# Service Manual

*Supplement*

**KX-TS2388CAB/KX-TS2388CAW/  
KX-TS2388RUB/KX-TS2388RUW/  
KX-TS2388UAB/KX-TS2388UAW/  
KX-TS880B/KX-TS880W/  
KX-TS880LXB/KX-TS880LXW/  
KX-TS880MLW/KX-TS880MXB/  
KX-TS880MXW/KX-TS880NDB/  
KX-TS880NDW/KX-TS880SAW/  
KX-TS881MXB/KX-TS881MXW/  
KX-TS889MXW/KX-TS108W**

Integrated Telephone System

NC: No Components  
KX-TS880 SCHEMATIC DIAGRAM (Main)

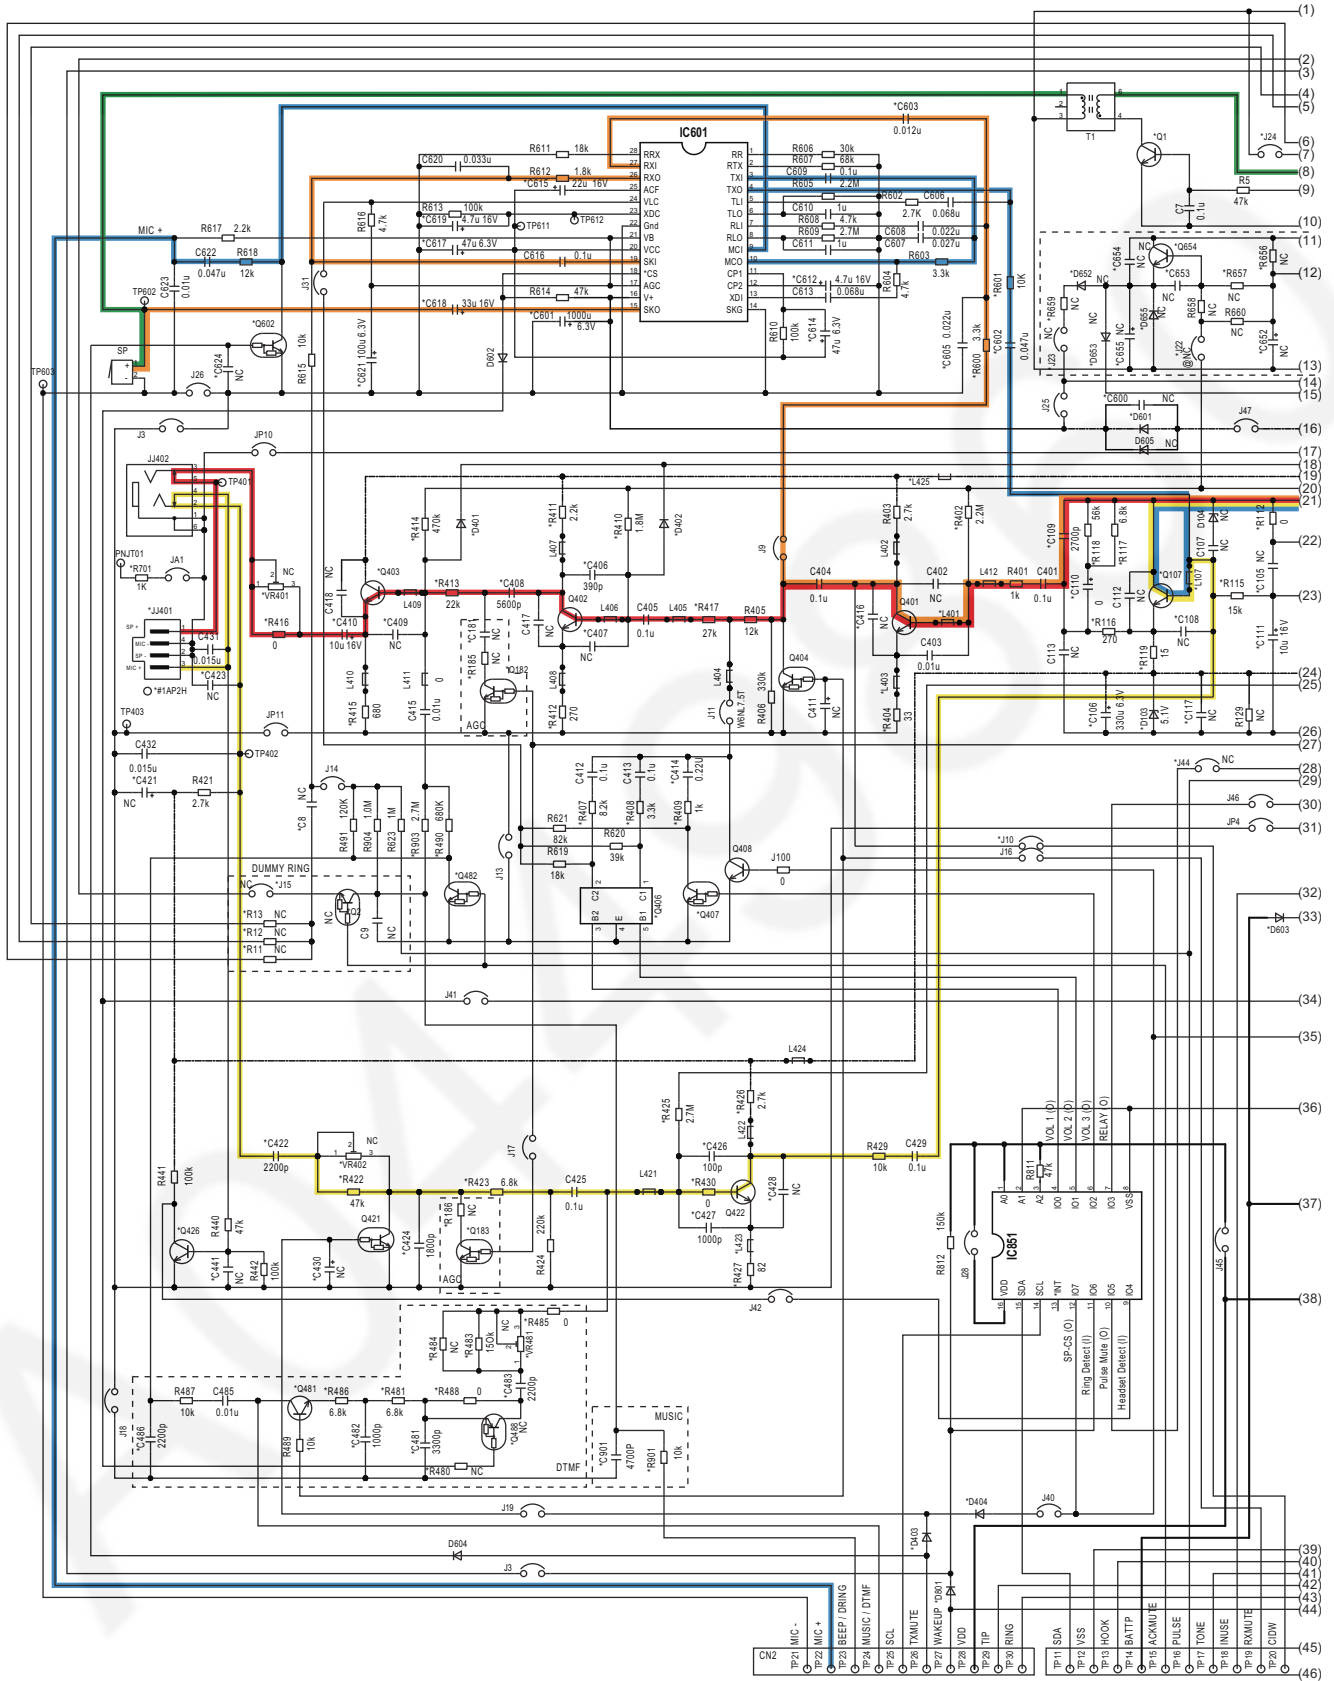
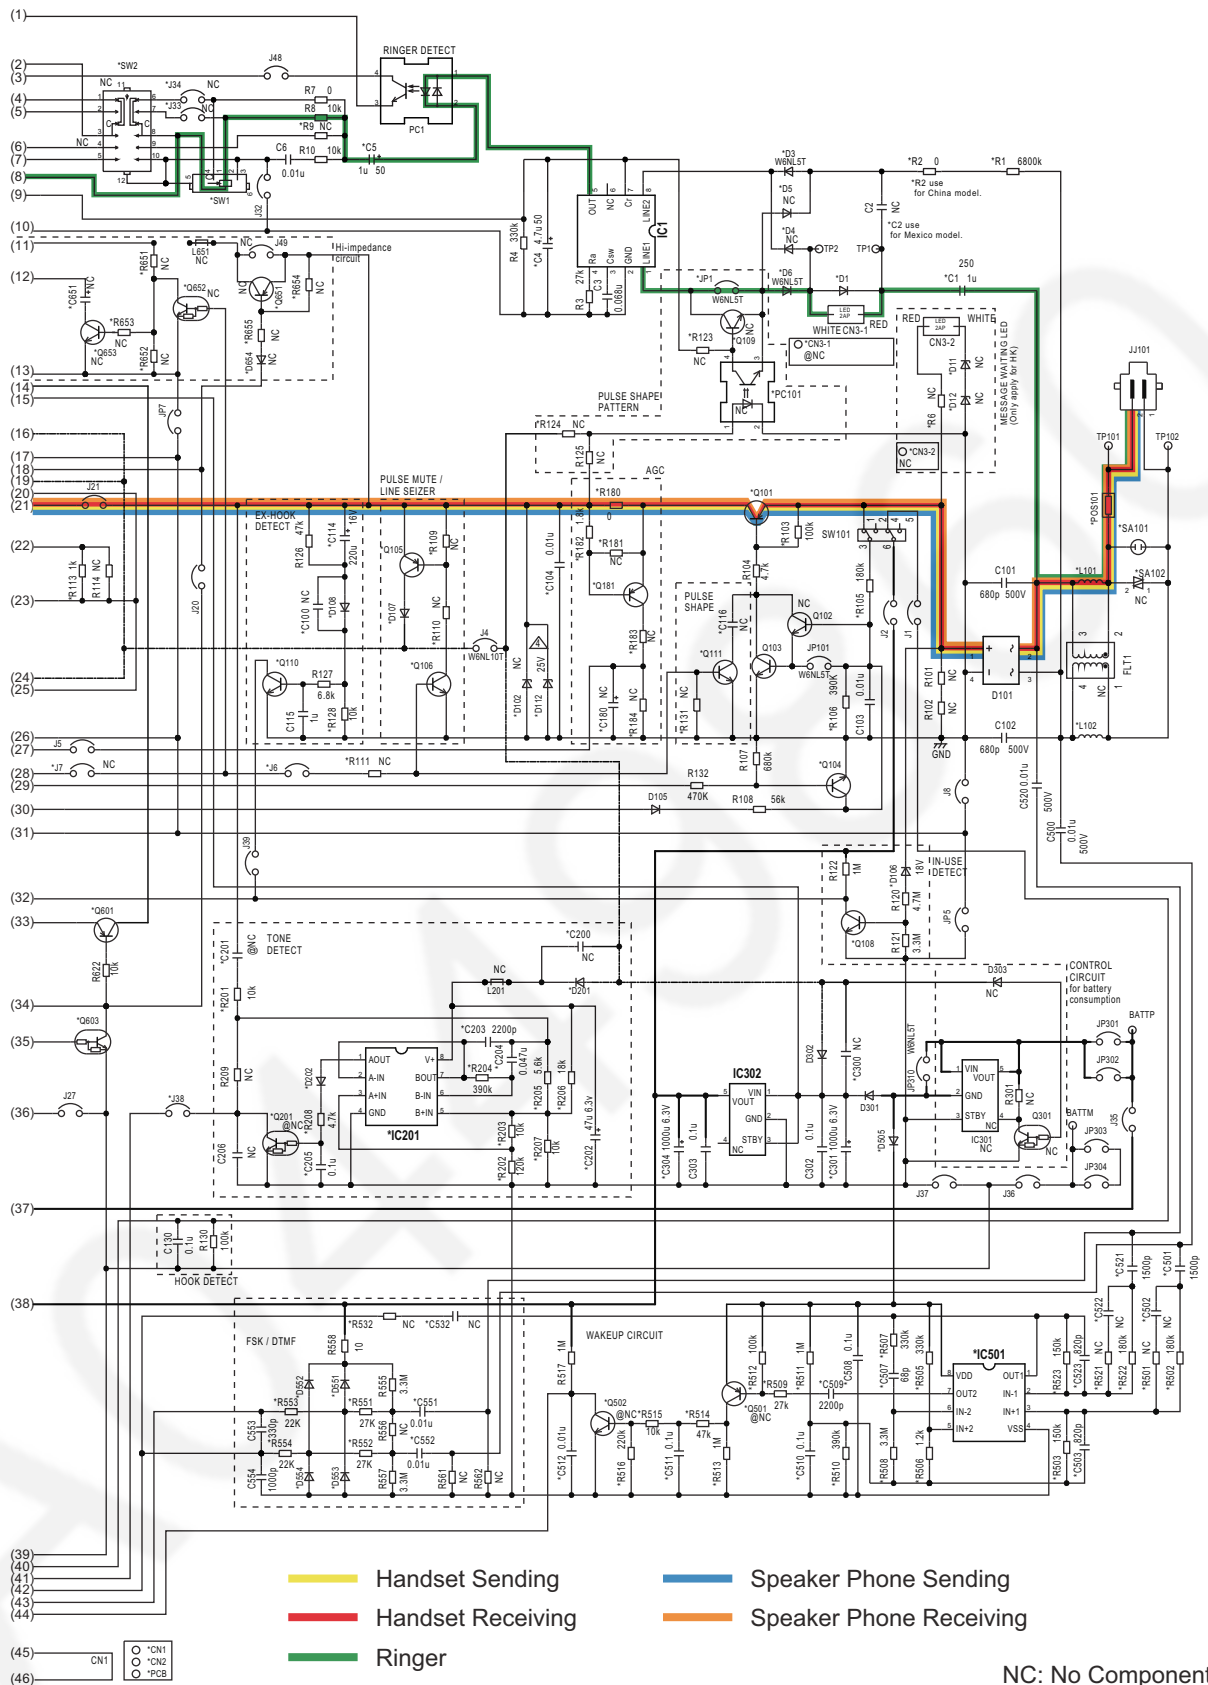
[Changed from original section "11.2. Schematic Diagram (Main)"]

NC: No Components  
 KX-TS880 SCHEMATIC DIAGRAM (Main)

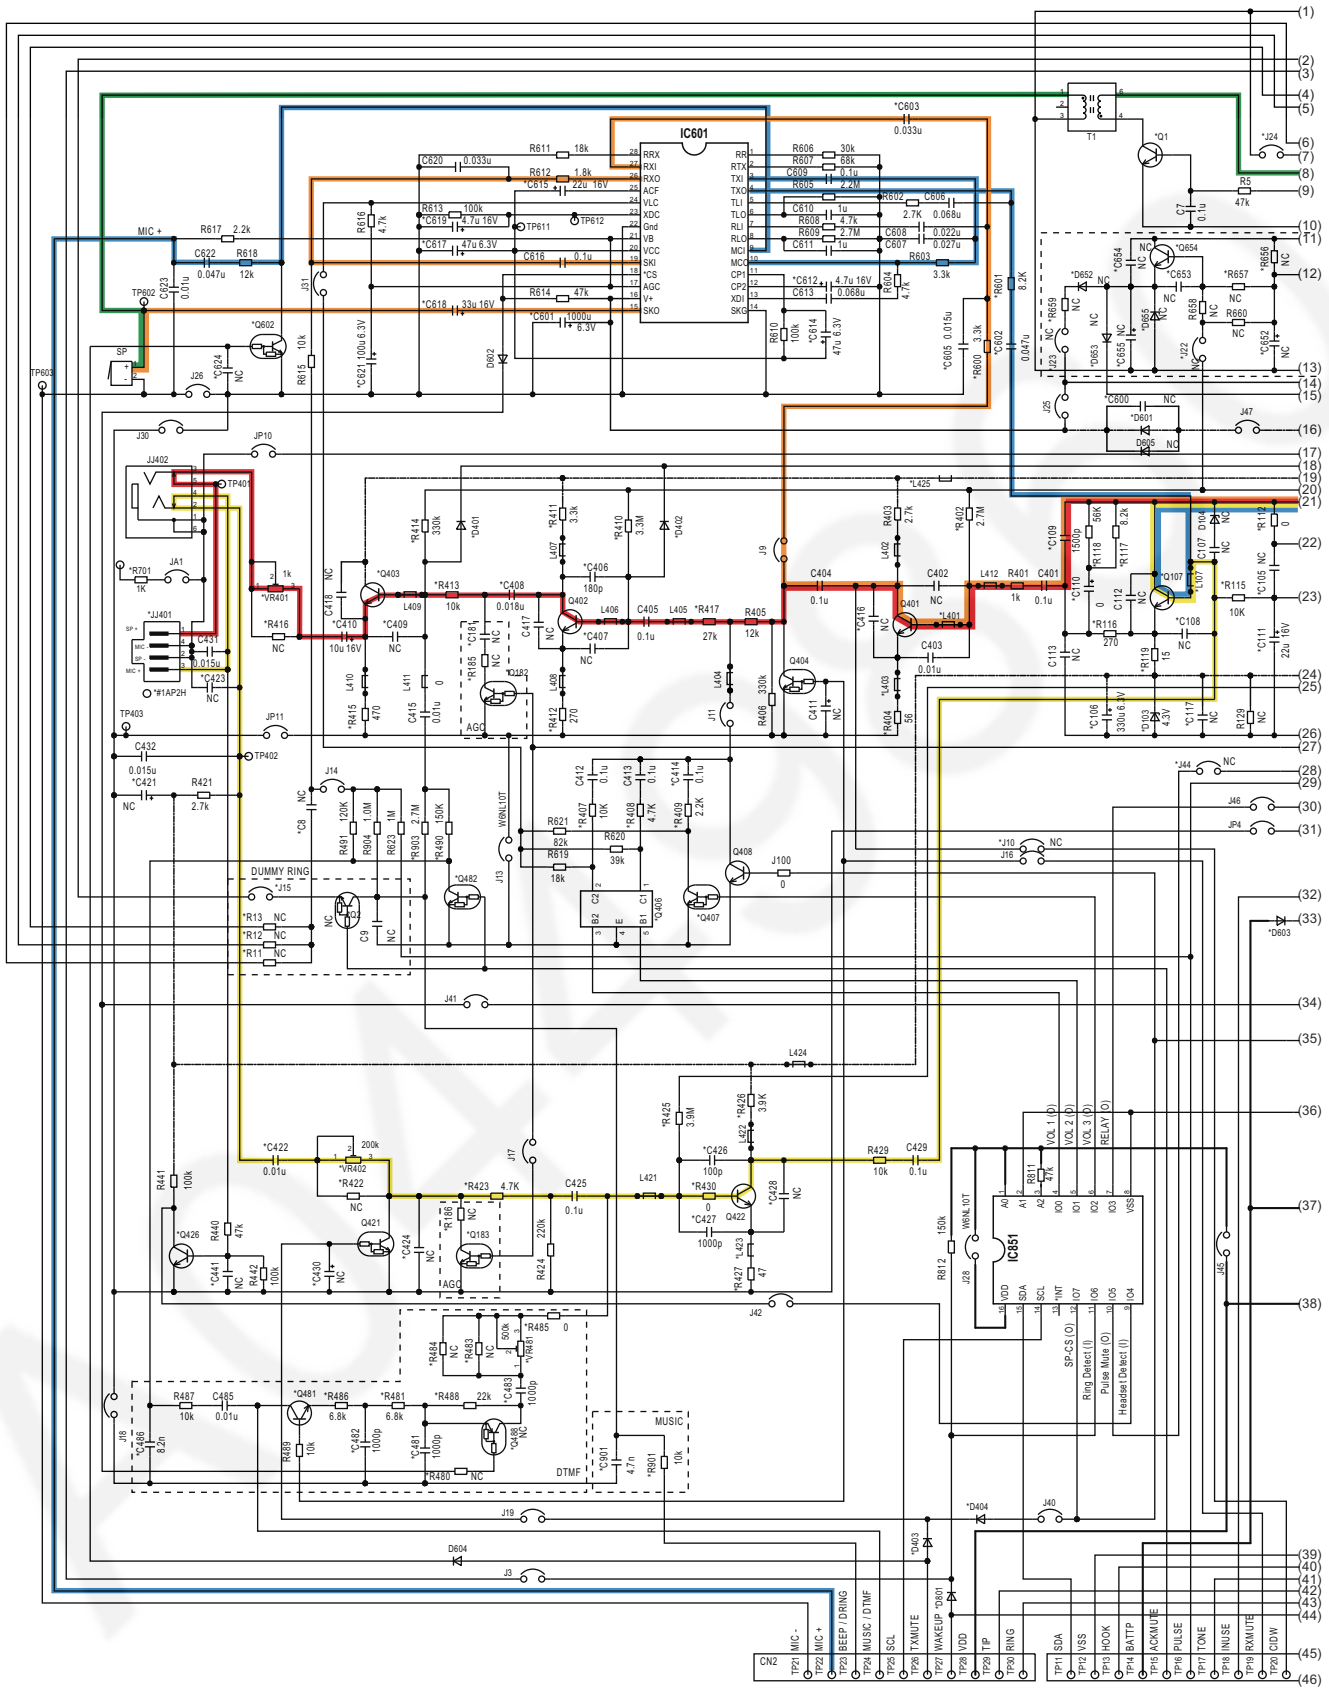
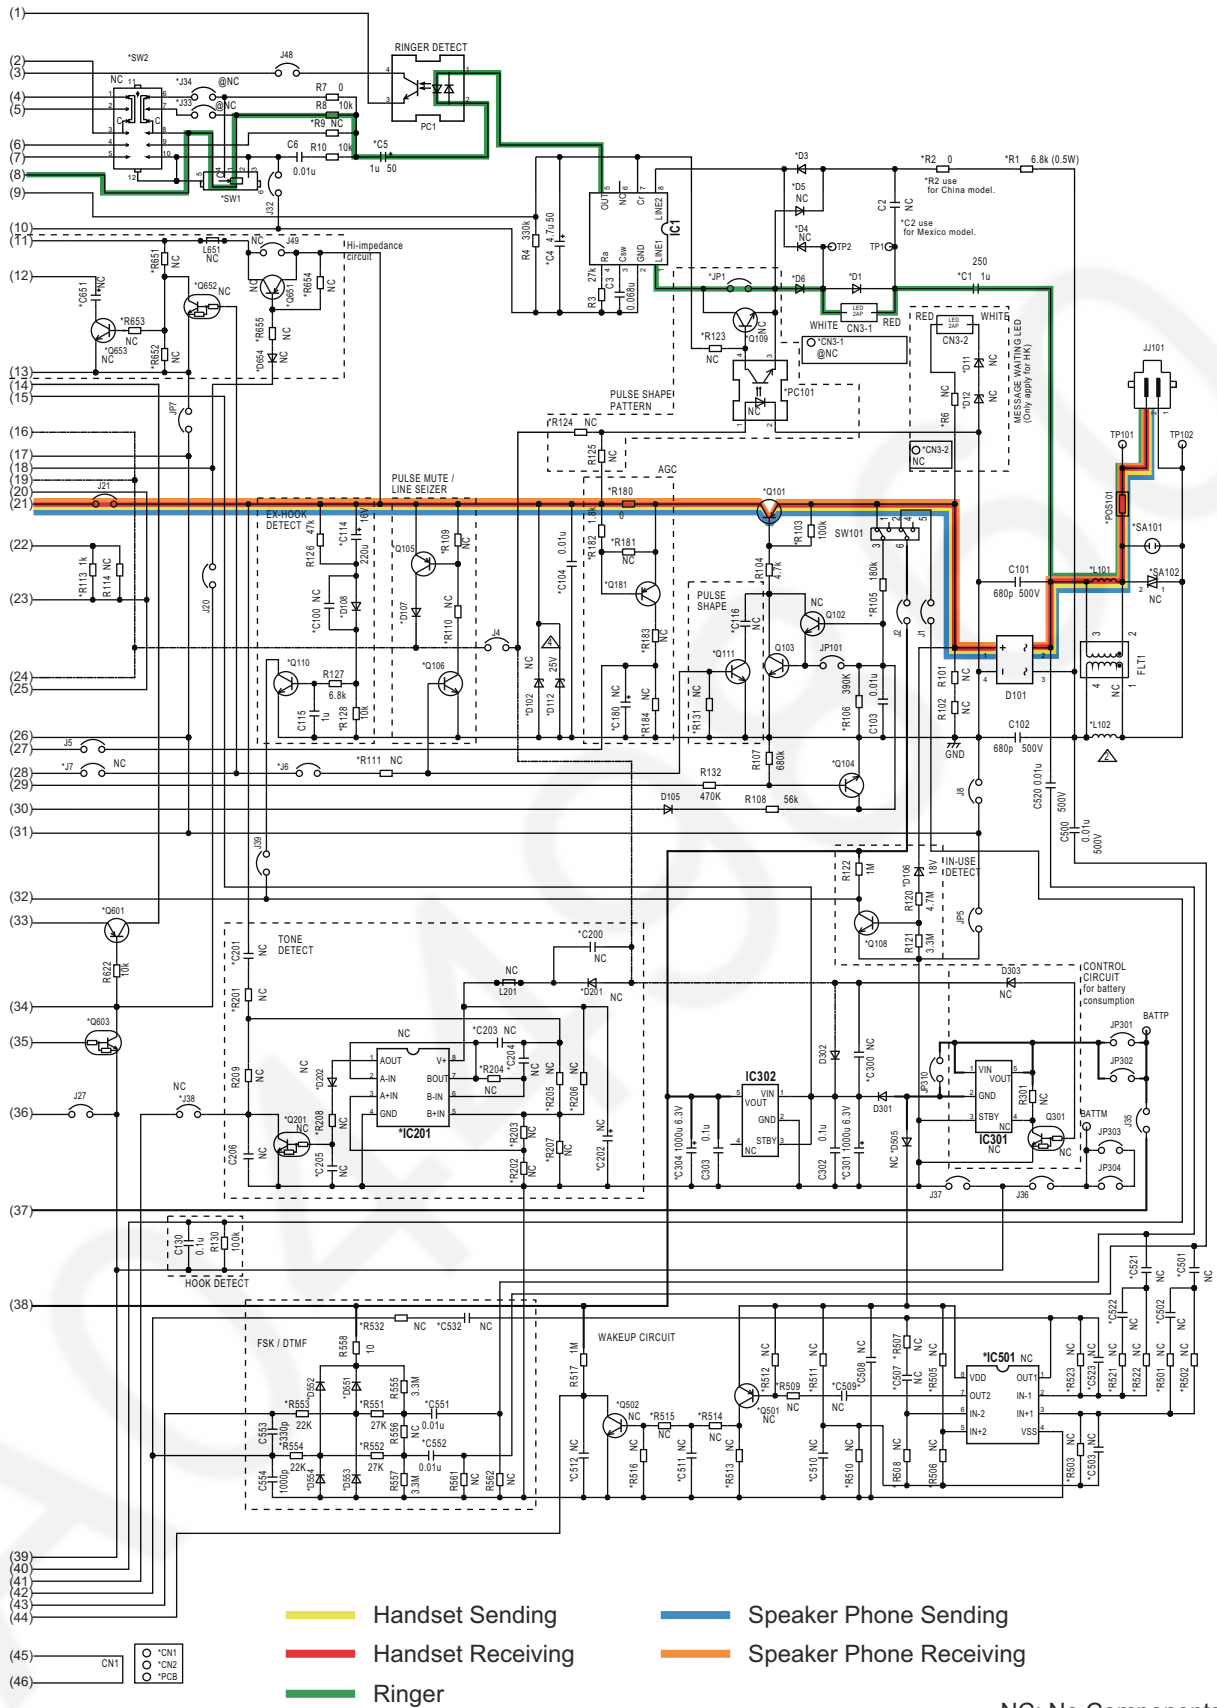
[Changed from original section "11.2. Schematic Diagram (Main)"]
